Access Compliance Report

Public Rights-of-Way

(Curb Ramps)

Intersection ID: 2593	Main Street: BEARDSLEY_DR	Cross Street: DURSTON_CT	Location: SE
ADA ID: 9C39FB29A01B	Ramp Type: PerpDiag	Initial Pass/Fail: Fail	Overall Compliance: No
Severity Score: 37.5			
Codes/Mitigation Info/Possible Solution		Field Measurements/Component Compliance

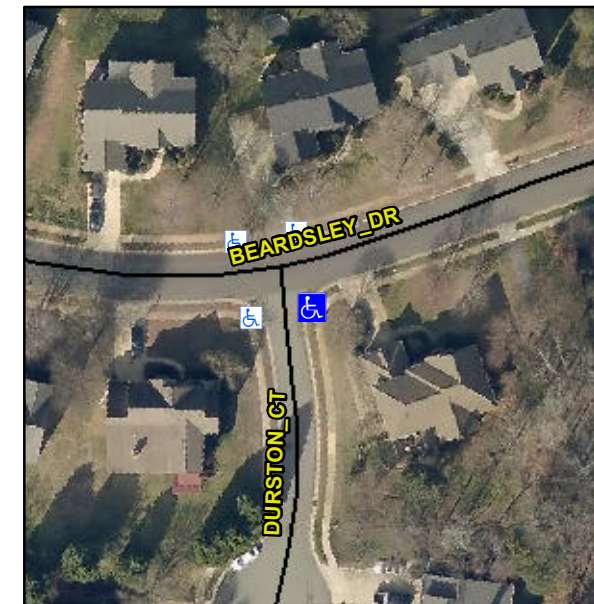
R304.2.2, R304.5.3

Compliance	Description	Data	Compliance	Description	Data
N/A	Ramp Length (in)	48.0	No	Ramp Slope (%)	12.3
Yes	Ramp Width (in)	48.0	No	Ramp XSlope (%)	6.2
N/A	Flare Type LT	N/A	N/A	Flare Type RT	N/A
N/A	Flare Slope LT (%)	N/A	N/A	Flare Slope RT (%)	N/A
N/A	Flare Traversable LT?	N/A	N/A	Flare Traversable RT?	N/A
N/A	Landing Length (in)	N/A	N/A	DWS Provided?	N/A
N/A	Landing Width (in)	N/A	N/A	DWS Contrast?	N/A
N/A	Landing Slope (%)	N/A	N/A	DWS Length (in)	N/A
N/A	Landing X Slope (%)	N/A	N/A	DWS Full Width?	N/A
N/A	Landing Curb? (Y/N)	N/A	N/A	DWS Offset (in)	N/A
N/A	Shared Landing?	N/A			
N/A	Gutter Ponding?	N/A	N/A	Gutter Slope (%)	N/A
N/A	Gutter Lip Ht (in)	N/A	N/A	Gutter X Slope (%)	N/A
N/A	Painted X Walk1?	No	N/A	Painted X Walk2?	No
	X Walk 1 Direction	To N		X Walk 2 Direction	To W
N/A	X Walk 1 Width (in)	N/A	N/A	X Walk 2 Width (in)	N/A
	X Walk 1 Slope (%)	4.4		X Walk 2 Slope (%)	2.3
	X Walk 1 X Slope (%)	1.3		X Walk 2 X Slope (%)	5.8

Remove & Replace Curb Ramp With Two New Directional Ramps or Equivalent.
